PLANNING REPORT

DUBLIN PLANNING AND ZONING COMMISSION

4. Tartan West, Subarea G, Decks and Patios **Corazon Drive**
09-081AFDP **Amended Final Development Plan**

Request: Review and approval of an Amended Final Development Plan under the Planned District provision of Code Section 153.050.

**Outdoor Amenity Areas**

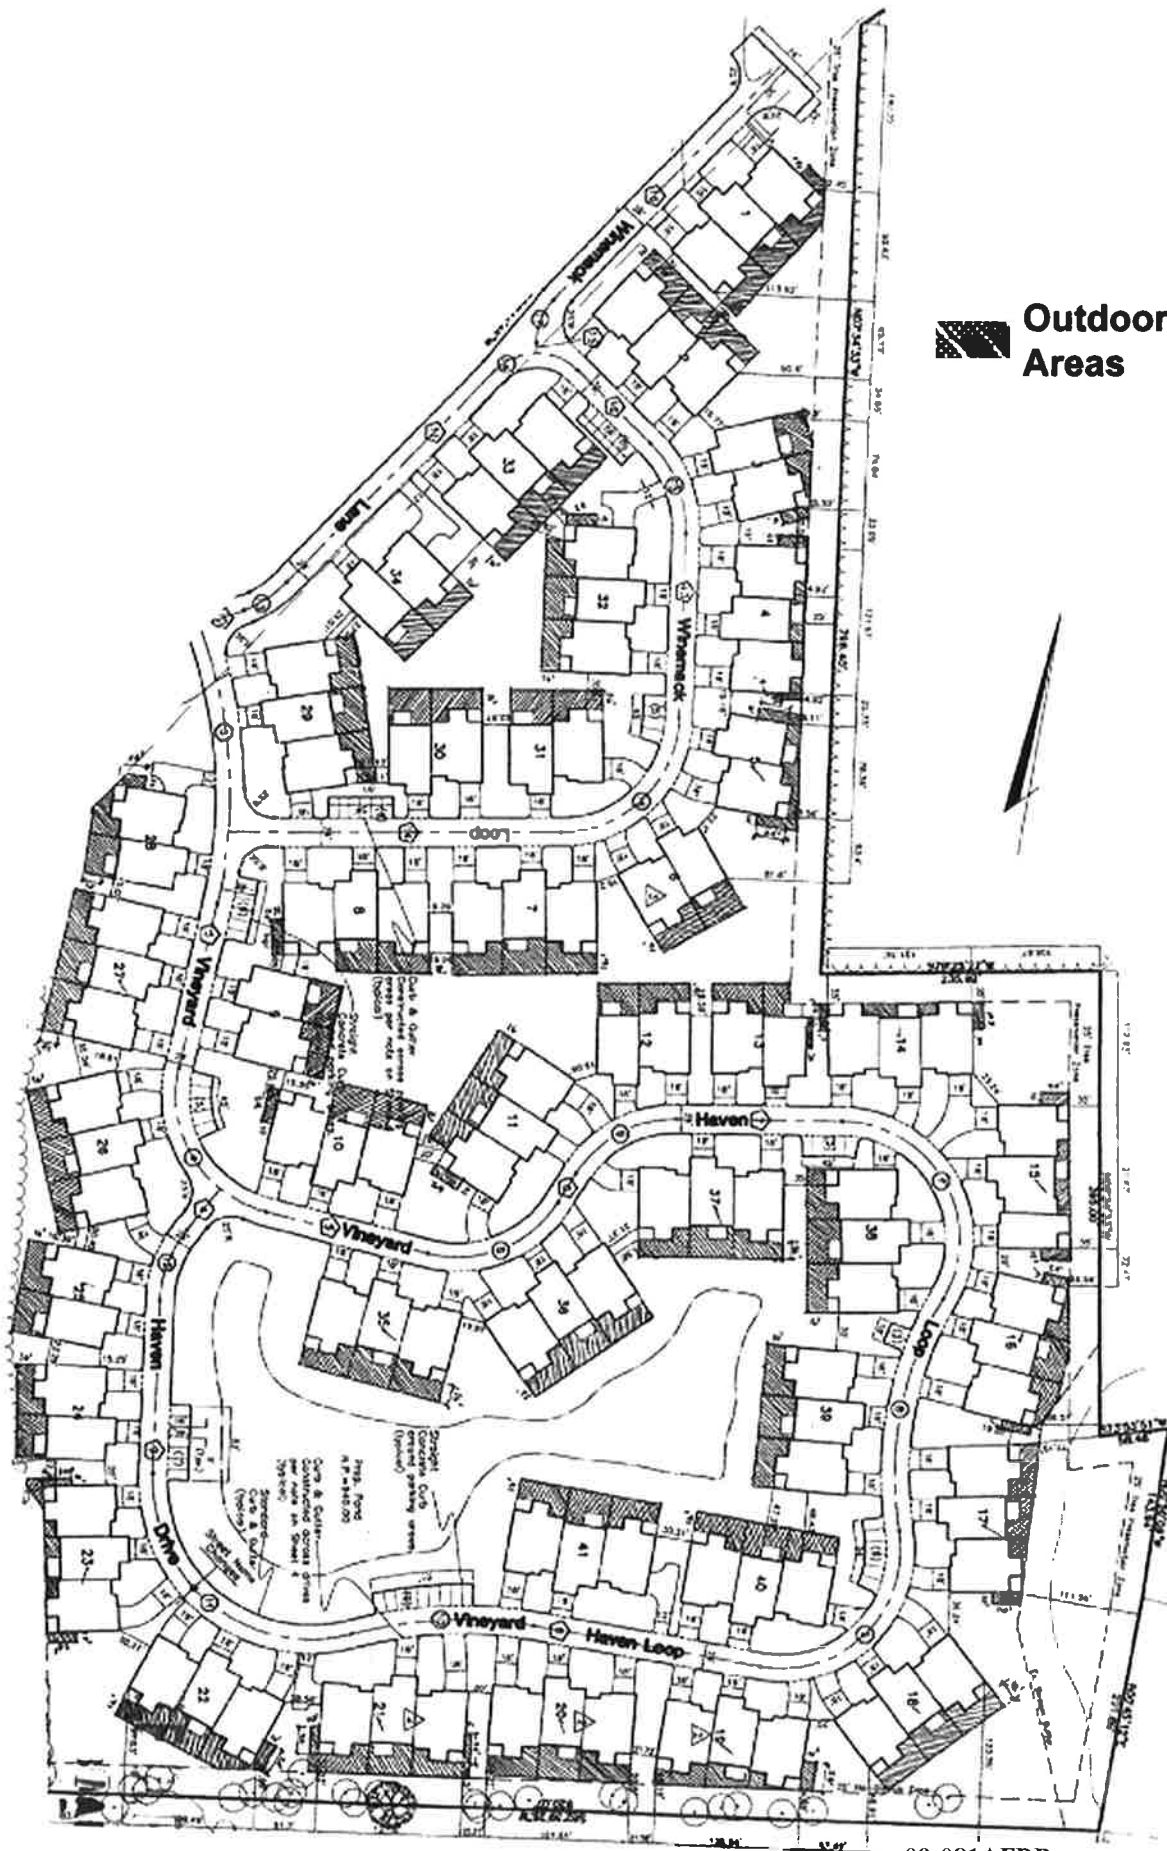
To the rear of each unit are proposed sunroom or screened porch options. In addition, there is a maximum allowable area designated for outdoor amenities such as decks and patios in the rear, and in some instances, to the side of each unit. As indicated on the plan, some units are limited on this outdoor amenity space due to the location of the unit. In these instances a smaller space is added to the side of the unit where appropriate. This proposed plan includes all the same elements that were previously approved by the Planning Commission, however, it now allows the owner more flexibility to arrange their outdoor amenities. This will also assist Planning in administering the approved amenities for each unit. The applicant will need to submit a final staking plan clearly articulating the outdoor amenity areas with all measurement delineated. Additionally, all necessary permits must be obtained prior to the construction of all future patios and decks.

The applicant is proposing that when outdoor amenities are built within six feet of each other, that additional landscaping will be provided for privacy and improved visual aesthetic. This landscaping must consist of a mix of evergreen shrubs and trees to coordinate with the existing planting scheme for the development. Planning will work with the applicant to field locate this material to achieve the most appropriate level of screening.

Criteria met with condition. The proposed site plan clarifies the intent of this high quality development and allows for owner flexibility and customization in the design of outdoor amenities. The plan also addresses outdoor privacy through landscaping and the coordinated architectural detail. The applicant will need to submit a final staking plan clearly articulating all as built conditions, with a note that any configuration of decks, patios, and the low stonewalls are permitted in the outdoor amenity areas with all necessary measurements delineated (Condition 1).

- 1) That the applicant submit a final staking plan clearly articulating all as built conditions, with a note that any configuration of decks, patios, and the low stonewalls are permitted in the outdoor amenity areas with all necessary measurements delineated.

PROPOSED SUNROOM AND SCREENED PORCHES

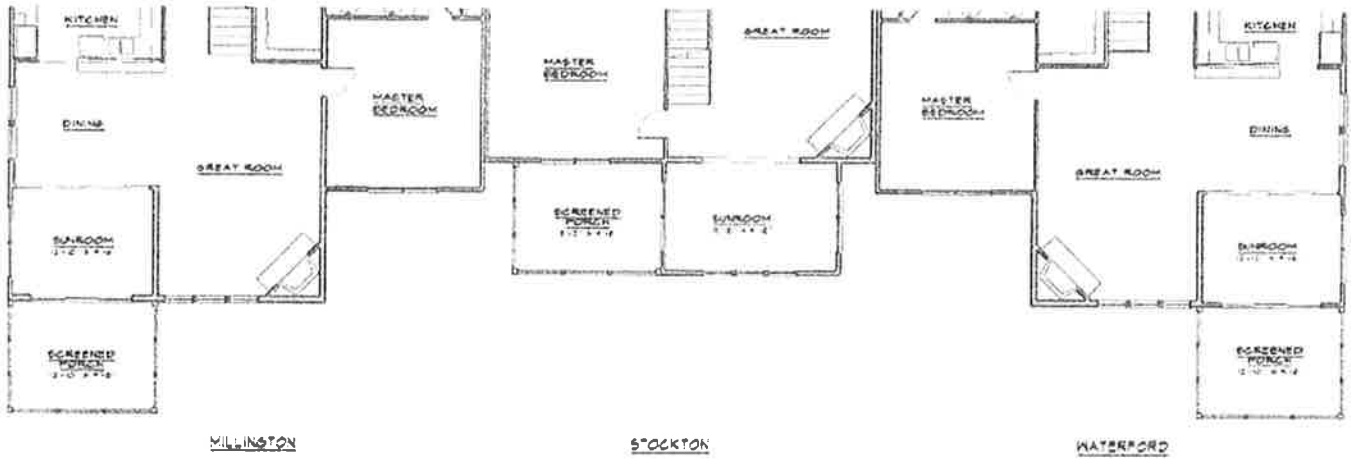
The architecture for the buildings was approved at the original final development plan, however, this approval did not include many details for the sunroom and screened porch. The original approval included an area for a sunroom or screened porch to the rear of each unit only with no flexibility on location or combination of the options. The proposed architecture includes variations of the sunroom and screened porch options that included gabled and flat roof options for the sunrooms and screened porches.

PROPOSED STONE WALL

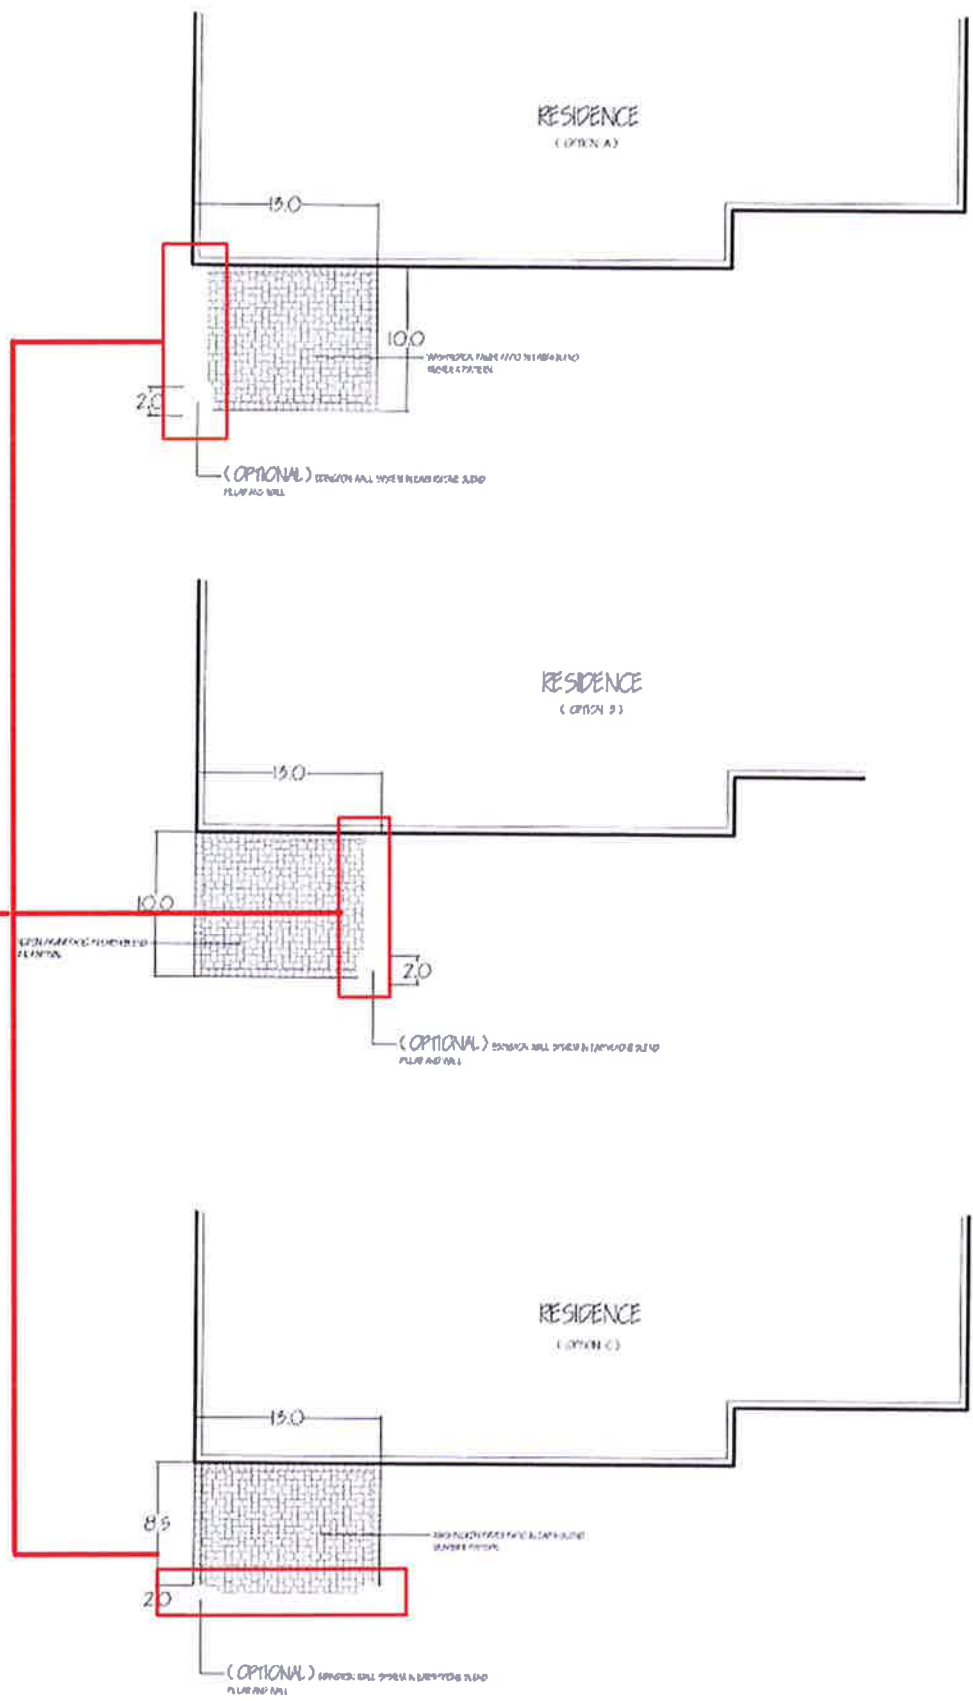
The previously approved materials will not change with this proposal and include one kind of material for the decks and another for the patios to ensure consistency and design compatibility. The deck material is LP WeatherBest Deep Grain decking in Chestnut and the patio paver will be Oberfields Washington style in Earth Blend. The applicant is also adding the option of a low

stone wall in the space that will be constructed of the patio paver material to coordinate with the overall design.
